**Visual Impact Evaluation of
Big Rivers Electric Corporation's
Application for a Certificate of Public
Convenience and Necessity to Construct
Two 161 kV Transmission Lines in
Hancock County, Kentucky**

Case No. 2015-00051

Prepared for:
Kentucky Public Service Commission

Prepared by:
Qk4, Inc

Figure 1. Aerial view of features in the study area.

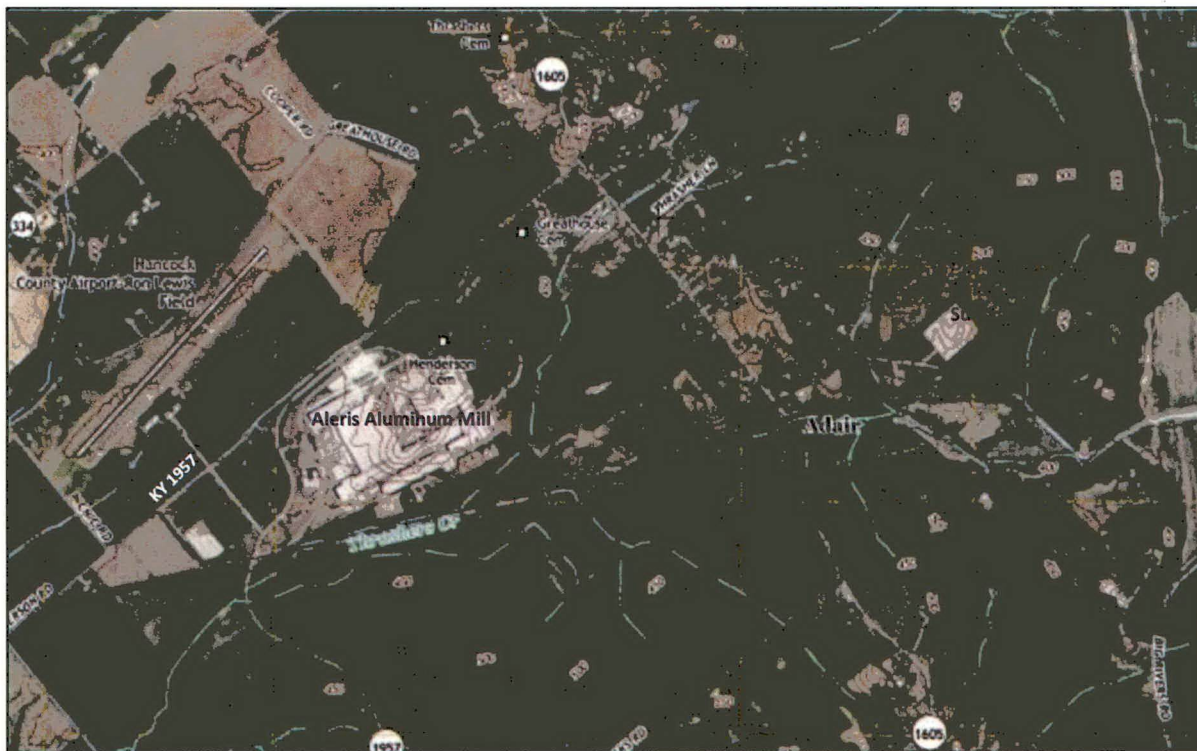
Visual character of the study area. The Ohio River is approximately 1.3 miles north and west of the Aleris aluminum mill. The study area features that are within a one-mile radius of the project present a visual character that is typical for this rural county—i.e., flat to rolling terrain encompassing primarily forested areas and land in agricultural (row crops) use. Other features of the study area include state roads KY 1957 (Lee Henderson Road) and KY 1605 (Adair Road); several local roads; Hancock County Airport—Ron Lewis Field, northwest of the aluminum mill; two Big Rivers’ transmission lines; the Seaboard System Railroad track running west-to-east across the study area immediately south of the mill; a soccer field west of the mill; three family cemeteries—Henderson, Greathouse, and Thrashers; and rural residential dwellings and farm structures on large parcels throughout the area. In addition to large areas of forest, natural features include Thrashers Creek and unnamed tributaries, a 6-acre lake northeast of the aluminum mill, and small farm ponds and wetlands. (See Figure 1.)

Figure 2. Existing transmission lines, and existing and proposed substation sites. (Source: *Technical Study*, Figure 7)

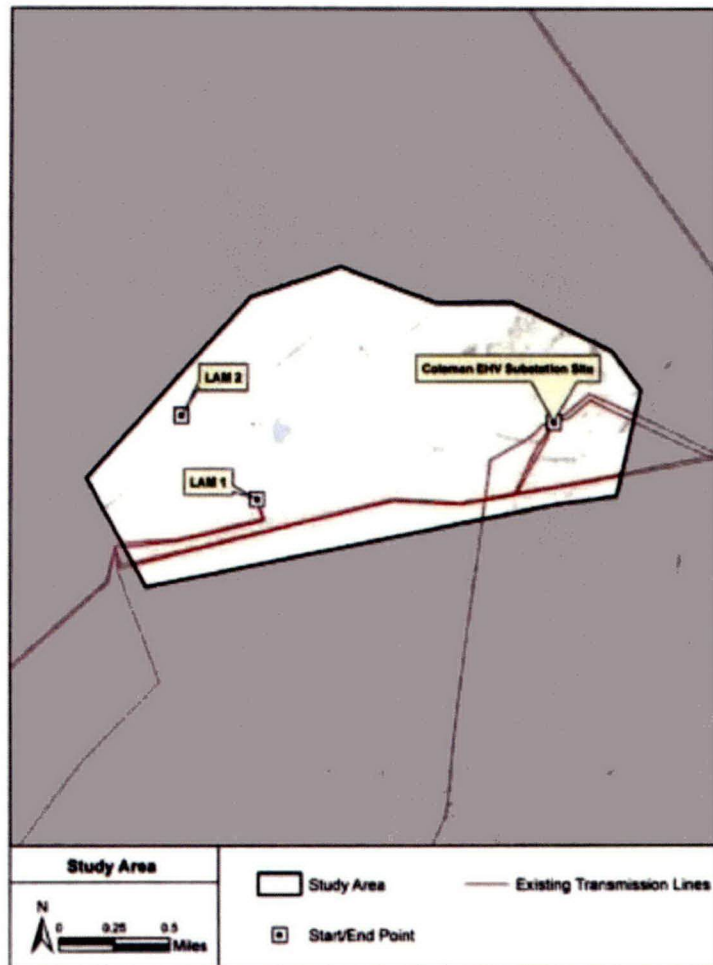
The first step in the route selection process was the development of “Macro Corridors, which defined an area for more detailed study.” The corridors were developed using a land cover dataset based on 30 meter LandSat imagery (2014). The Macro Corridors were used to identify a 2.28-square-mile study area centered on the area between the Coleman EHV Substation, LAM 1, and LAM 2. (See Figure 2.)

FIGURE 3-a. Aerial view of Big Rivers' proposed transmission line Routes B (Blue) and D (Orange). Numbers represent the locations of photos 1–15 that are provided as Figures 3-b through 3-p on the following pages.

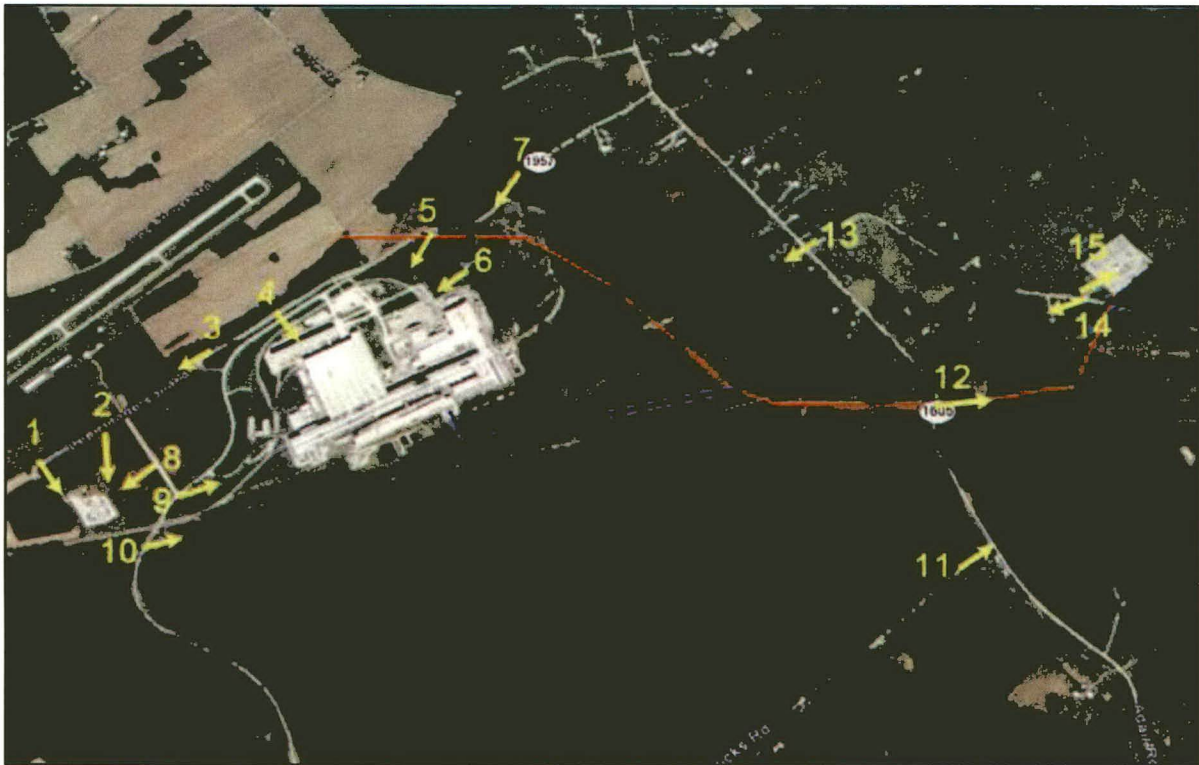
The team took numerous photographs to assist the Commission in its evaluation. Figure 3-a, on the following page, depicts the alignments for Routes B and D and shows the locations of the photographs that follow (Figures 3-b through 3-p).
